Subject: FCC Class II Permission change for FCC ID: 2AAGEVTM2M-LV.

Original Grant Date: 2015-06-04

This is to request a Class II permission change to our product name: M2M Gateway, Models: VT-M2M-LV, FCC ID: 2AAGEVTM2M-LV, the device is identical to the previously certified except for the changes as below,

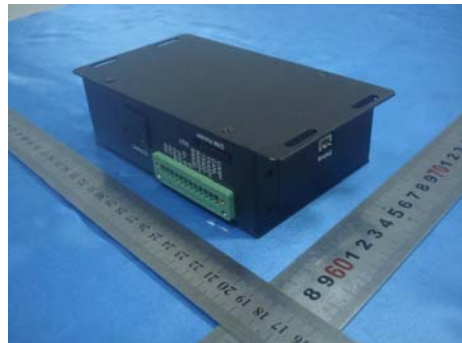
3.Updating EUT external picture,

Original:

Current:
